**WHITESTONE**  
solar farm

# Targeted Consultation Leaflet

4 March – 3 April 2026

## **We are now carrying out an additional, targeted consultation on proposed changes to the boundary of Whitestone Solar Farm, known as the ‘draft order limits’.**

# Change 21: Road Safety South of South Anston

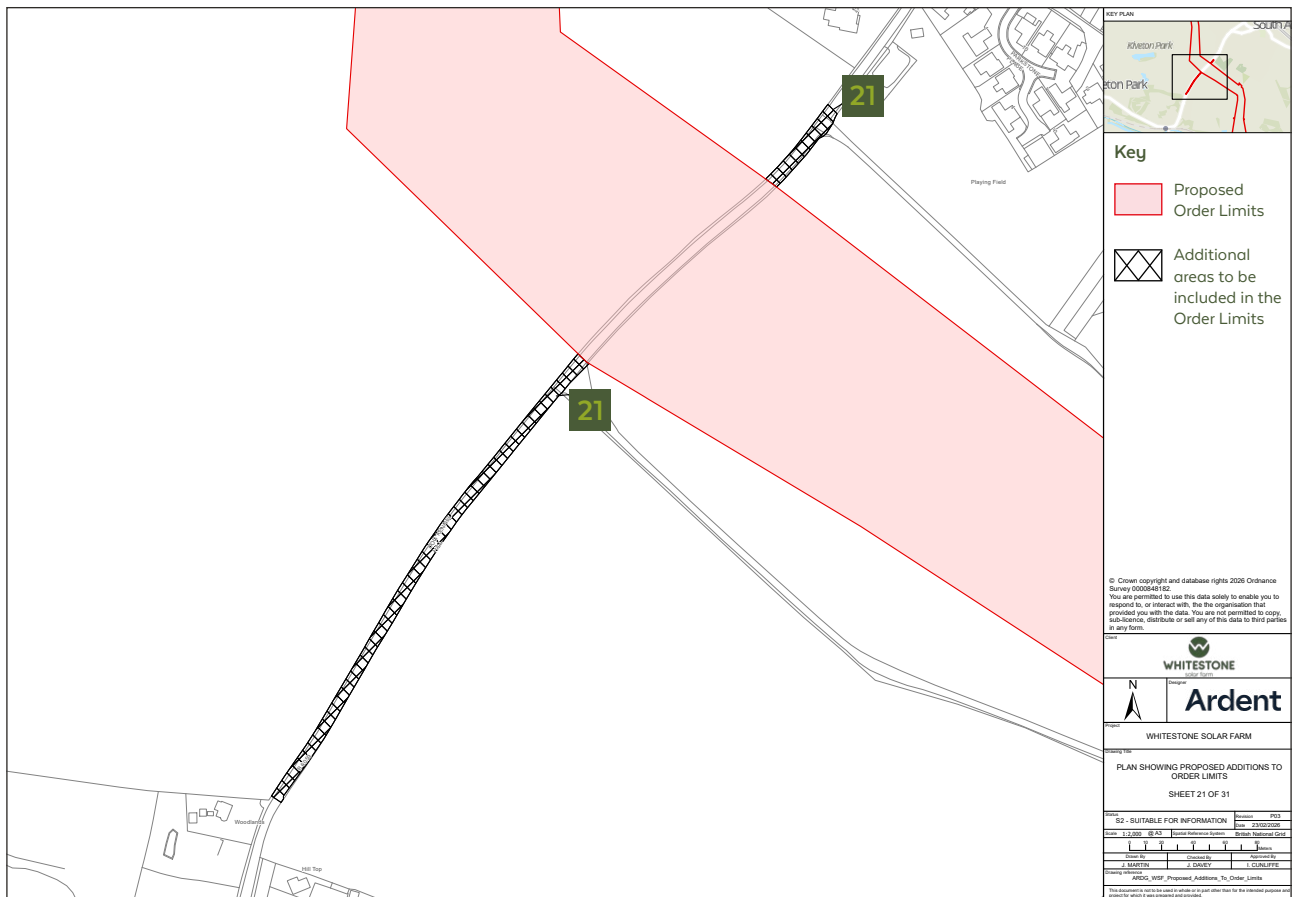
**Description of Change:** Additional land is proposed along Crowgate and Dog Kennels Hill south of South Anston to allow the proposed access to Cable Route L, to comply with highway safety standards for visibility and temporary speed limits if required. The works could include trimming hedges or roadside vegetation for safe visibility, temporary road signage for managing safe access and temporary speed limits during construction if required.

**Impact of Change:** This change may lead to the loss of hedgerow and roadside vegetation. This impact is already being considered within the EIA being undertaken to support the Proposed Development. The Proposed Development will include commitments to planting new hedgerows and creation of additional areas of habitat including safeguarding of any species as needed. With suitable mitigation, this change is unlikely to lead to significant adverse effects.

# Change 22: Road Safety South of South Anston

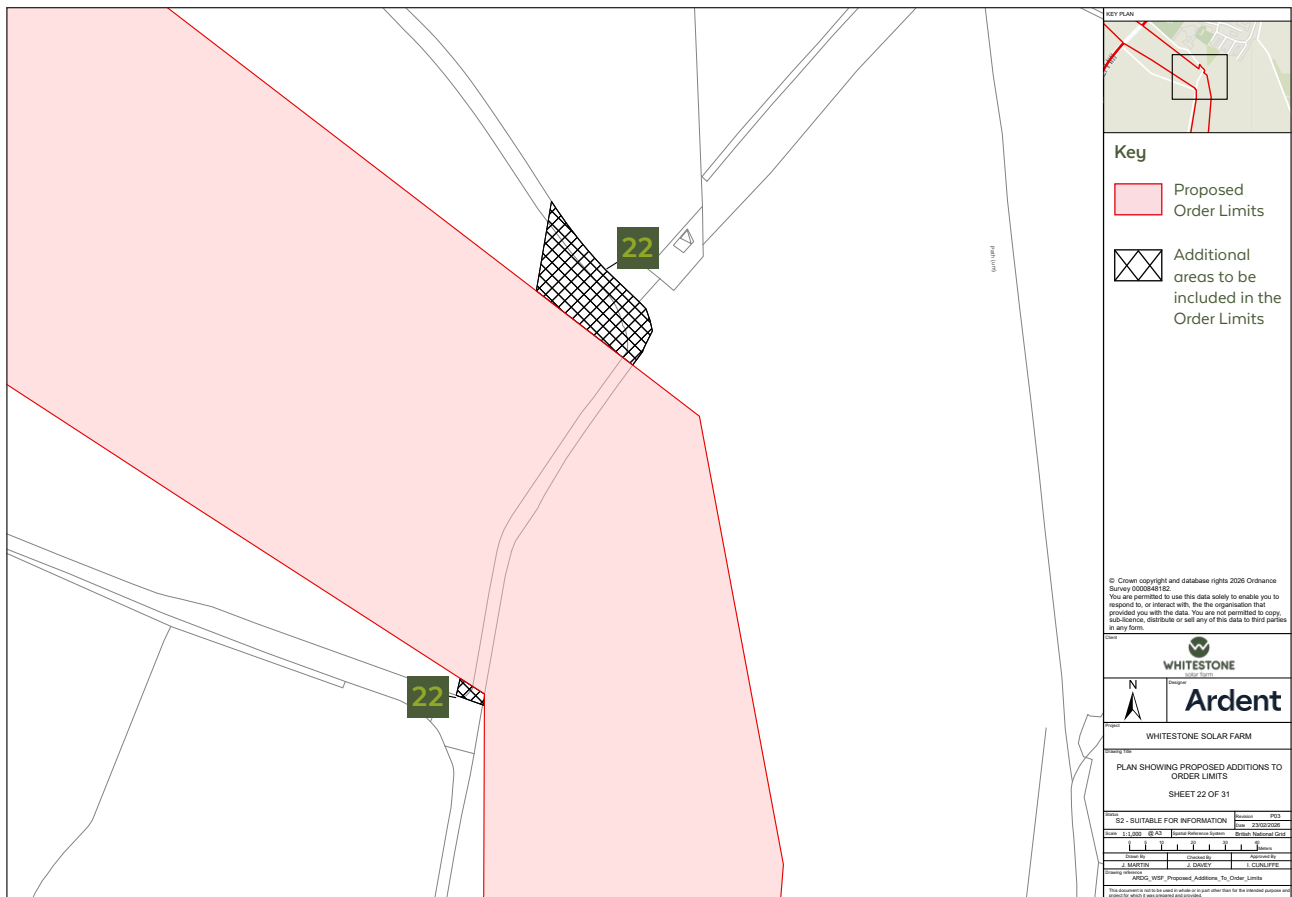
**Description of Change:** Additional land is proposed along the track south of South Anston to allow the proposed access to Cable Route L, to comply with highway safety standards for visibility and temporary speed limits if required. The works could include trimming hedges or roadside vegetation for safe visibility, temporary road signage for managing safe access and temporary speed limits during construction if required.

**Impact of Change:** This change may lead to the loss of hedgerow and roadside vegetation. This impact is already being considered within the EIA being undertaken to support the Proposed Development. The Proposed Development will include commitments to planting new hedgerows and creation of additional areas of habitat including safeguarding of any species as needed. With suitable mitigation, this change is unlikely to lead to significant adverse effects.

# Change 23: Road Safety South of South Anston

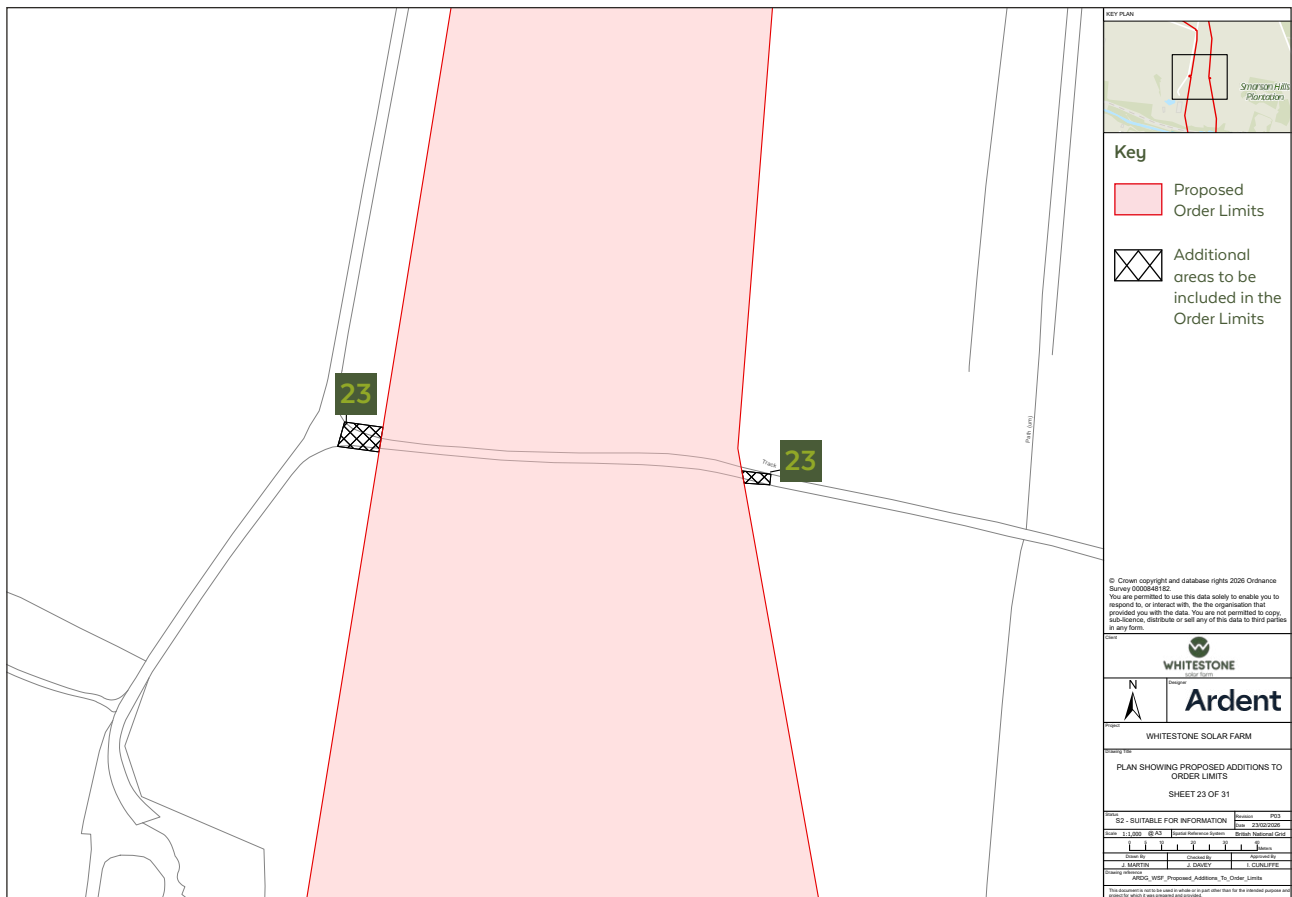
**Description of Change:** Additional land is proposed along a track south of South Anston to allow the proposed access to Cable Route L, to comply with highway safety standards for visibility and temporary speed limits if required. The works could include trimming hedges or roadside vegetation for safe visibility, temporary road signage for managing safe access and temporary speed limits during construction if required.

**Impact of Change:** This change may lead to the loss of hedgerow and roadside vegetation. This impact is already being considered within the EIA being undertaken to support the Proposed Development. The Proposed Development will include commitments to planting new hedgerows and creation of additional areas of habitat including safeguarding of any species as needed. With suitable mitigation, this change is unlikely to lead to significant adverse effects.

# Change 24: Road Safety East of Kiveton Park Station

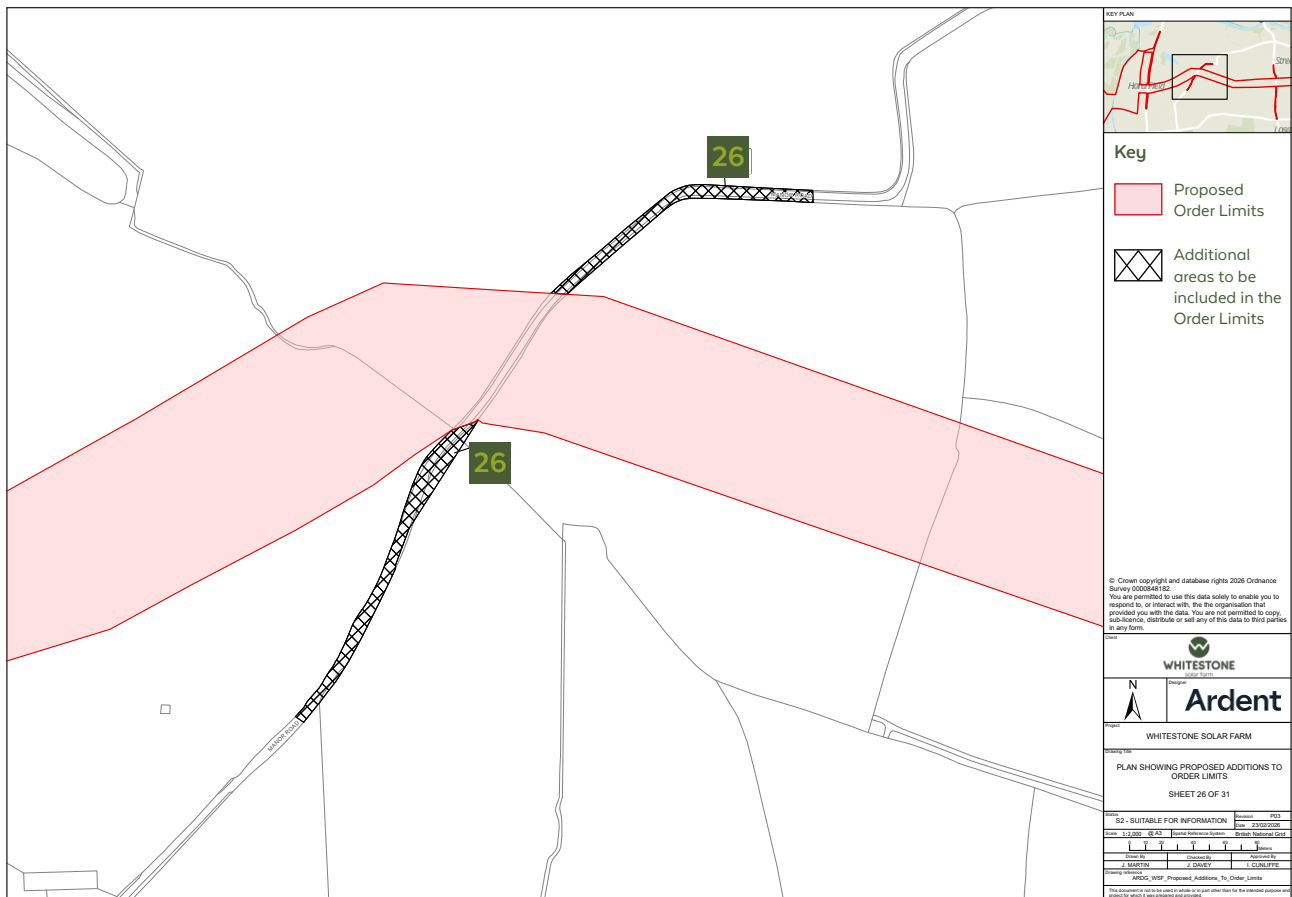
**Description of Change:** Additional land is proposed along Ladyfield Road between Kiveton Park Station and Thorpe Salvin to allow the proposed access to Cable Route L, to comply with highway safety standards for visibility and temporary speed limits if required. The works could include trimming hedges or roadside vegetation for safe visibility, temporary road signage for managing safe access and temporary speed limits during construction if required.

**Impact of Change:** This change may lead to the loss of hedgerow and roadside vegetation. This impact is already being considered within the EIA being undertaken to support the Proposed Development. The Proposed Development will include commitments to planting new hedgerows and creation of additional areas of habitat including safeguarding of any species as needed. With suitable mitigation, this change is unlikely to lead to significant adverse effects.

# Change 27: Road Safety North of Harthill

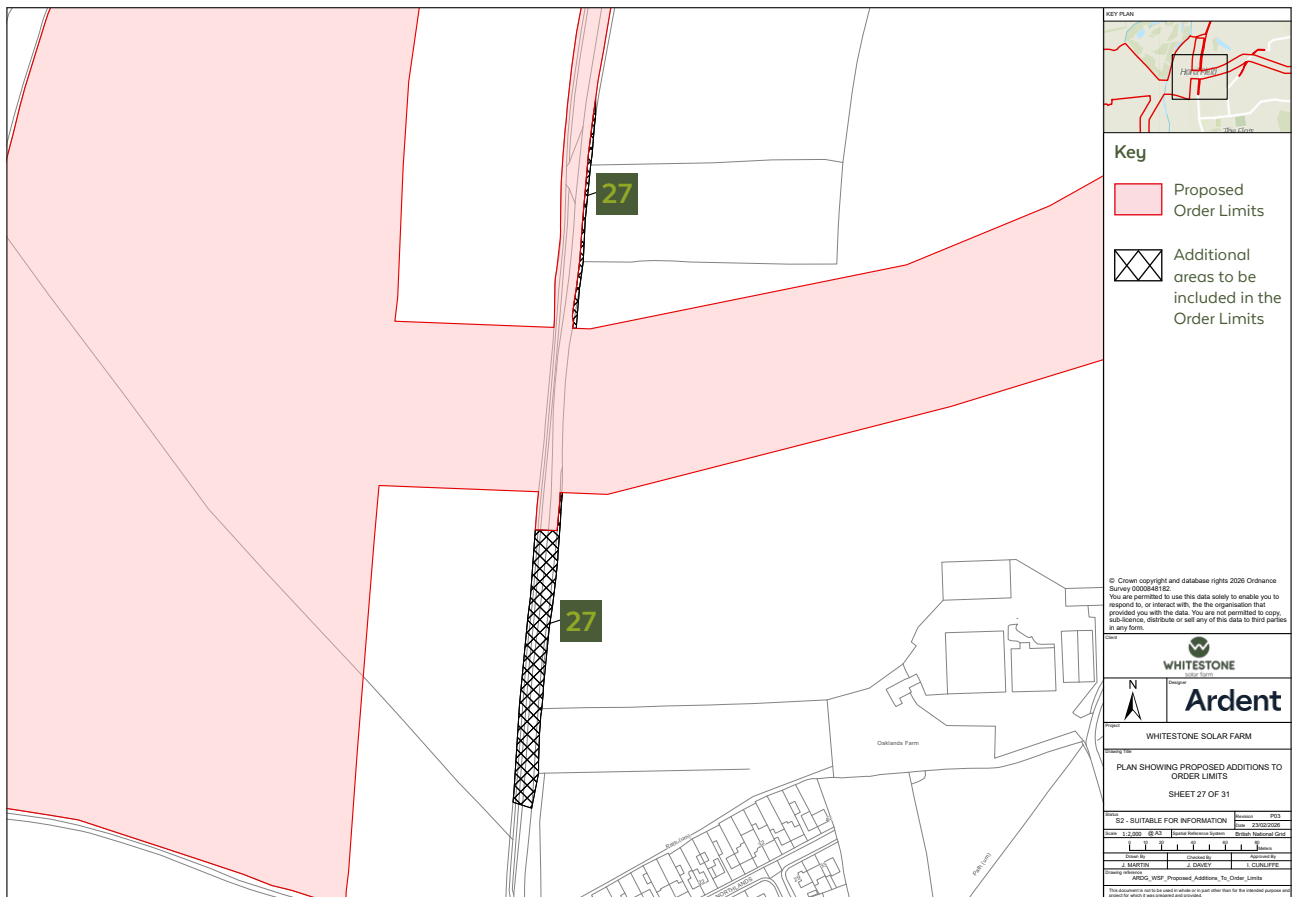
**Description of Change:** Additional land is proposed along Hard Lane north of Harthill to allow the proposed access to Cable Route L, to comply with highway safety standards for visibility and temporary speed limits if required. The works could include trimming hedges or roadside vegetation for safe visibility, temporary road signage for managing safe access and temporary speed limits during construction if required.

**Impact of Change:** This change may lead to the loss of hedgerow and roadside vegetation. This impact is already being considered within the EIA being undertaken to support the Proposed Development. The Proposed Development will include commitments to planting new hedgerows and creation of additional areas of habitat including safeguarding of any species as needed. With suitable mitigation, this change is unlikely to lead to significant adverse effects.

## Change 28: Landscaping North of Woodall

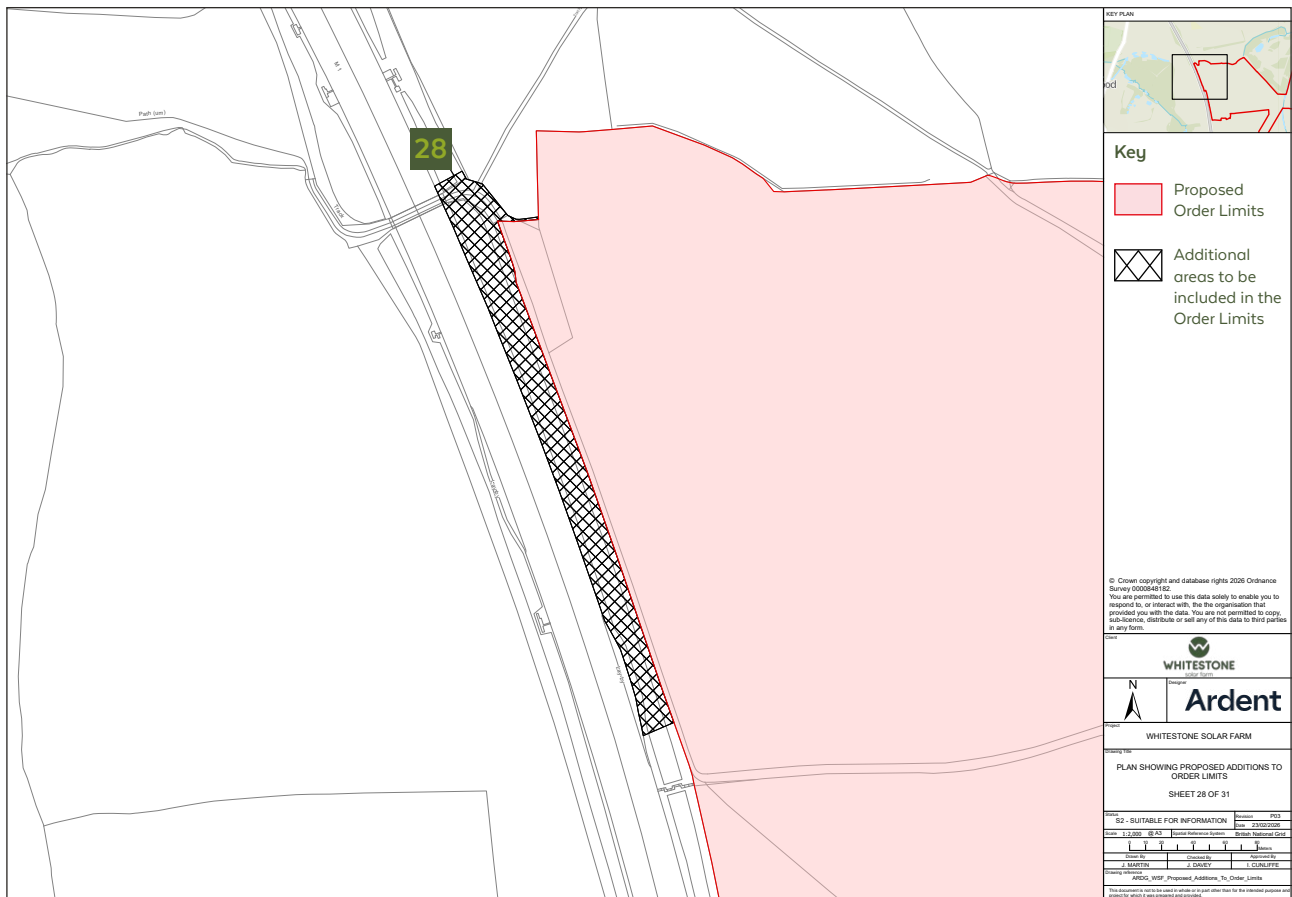
**Description of Change:** This additional land along the M1 north of Woodall is being proposed for landscaping to minimise potential glint and glare impacts on the adjacent road. Works could include the planting of trees, hedges or other landscaping and visual barriers as needed.

**Impact of Change:** The impact is dependent on type of visual screening. There is a preference for planting of hedgerows and trees which would have beneficial impacts on habitat creation and connectivity. It may be necessary to install temporary fencing whilst vegetation establishes, however it is expected that any adverse impact would be not significant as receptors would be driving and views impacted would be fleeting.

# Change 29: Cable Route and Road Safety between Harthill and Woodall

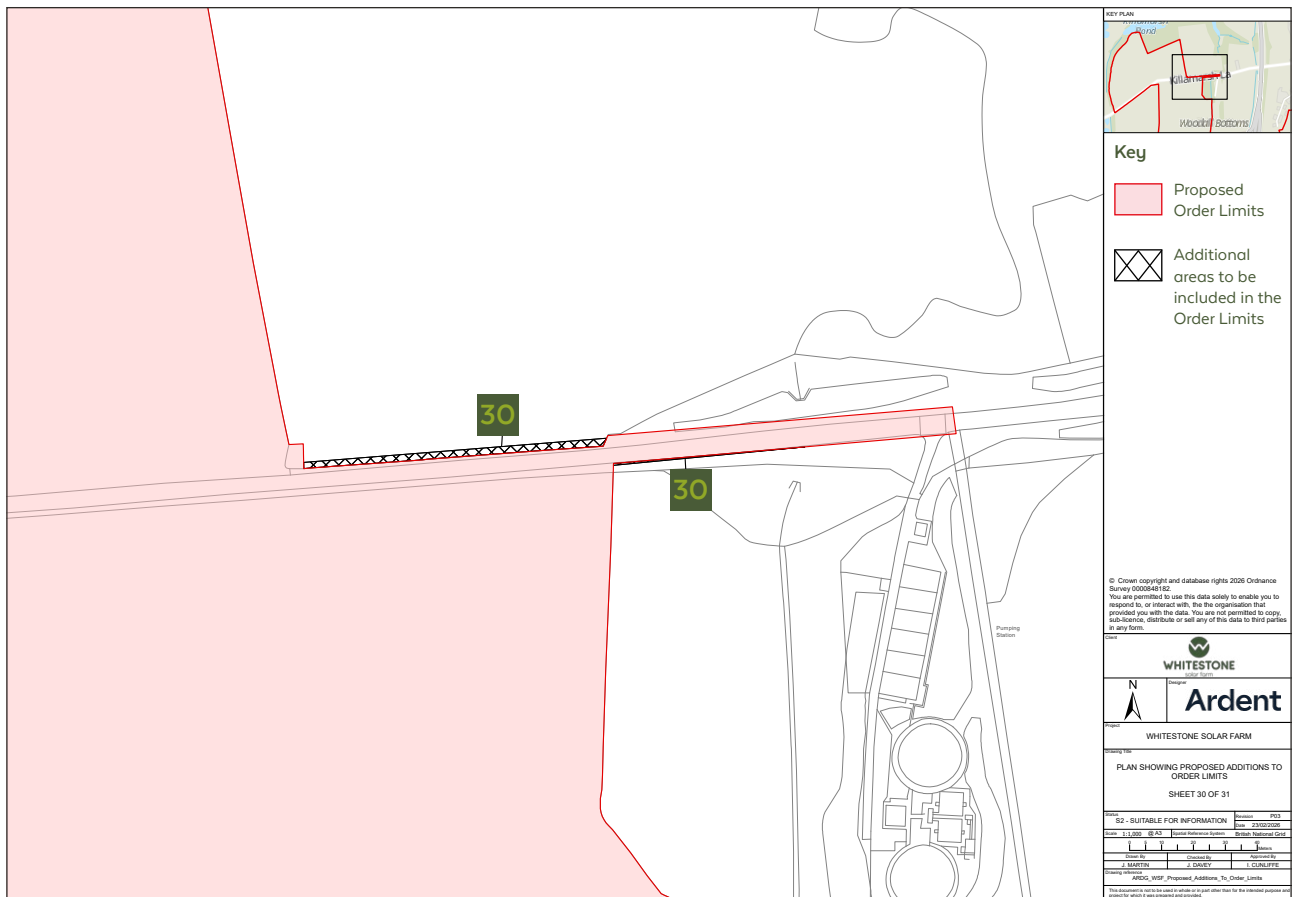
**Description of Change:** Additional land along Woodall Lane between Harthill and Woodall is being proposed to allow the proposed access to Cable Route M, to comply with highway safety standards for visibility and temporary speed limits if required. The works could include trimming hedges or roadside vegetation for safe visibility, temporary road signage for managing safe access and temporary speed limits during construction if required.

Additional land south of Woodall Lane is proposed to move the cable route slightly west in response to consultation with the Canal and Rivers Trust to avoid or reduce the impact to the access to the nearby spillway for Harthill Reservoir.

**Impact of Change:** This change may lead to the loss of hedgerow and roadside vegetation. This impact is already being considered within the EIA being undertaken to support the Proposed Development. The Proposed Development will include commitments to planting new hedgerows and creation of additional areas of habitat including safeguarding of any species as needed. With suitable mitigation, this change is unlikely to lead to significant adverse effects. Moving the cable route further away from the Canal and Rivers Trust asset is a beneficial change to reduce potential impacts to the reservoir.

## Change 31: Road Safety East of High Moor

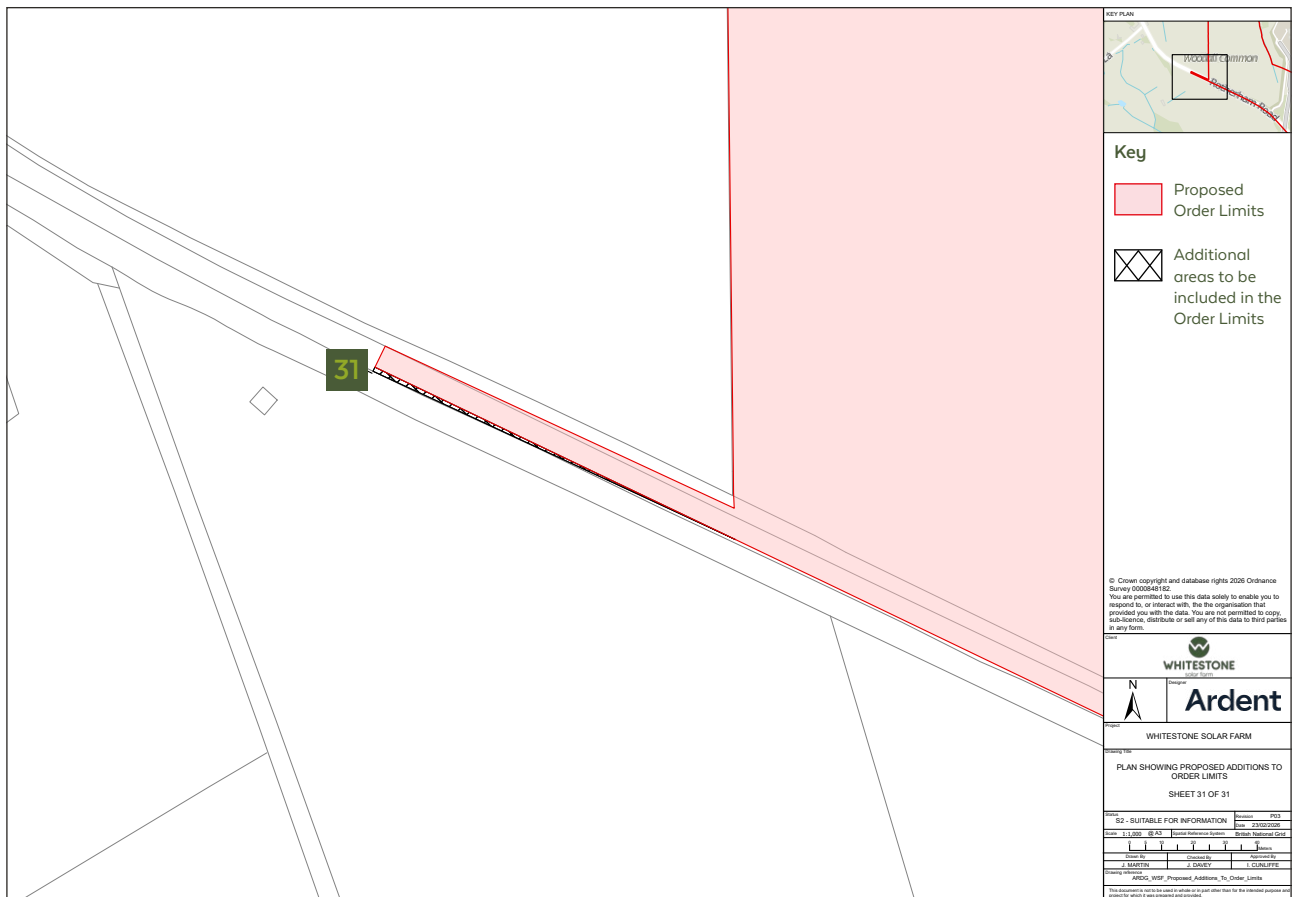
**Description of Change:** Additional land is proposed to allow the proposed access to solar area to comply with highway safety standards for visibility and temporary speed limits if required. The works could include trimming hedges or roadside vegetation for safe visibility, temporary road signage for managing safe access and temporary speed limits during construction if required.

**Impact of Change:** This change may lead to the loss of hedgerow and roadside vegetation. This impact is already being considered within the EIA being undertaken to support the Proposed Development. The Proposed Development will include commitments to planting new hedgerows and creation of additional areas of habitat including safeguarding of any species as needed. With suitable mitigation, this change is unlikely to lead to significant adverse effects.
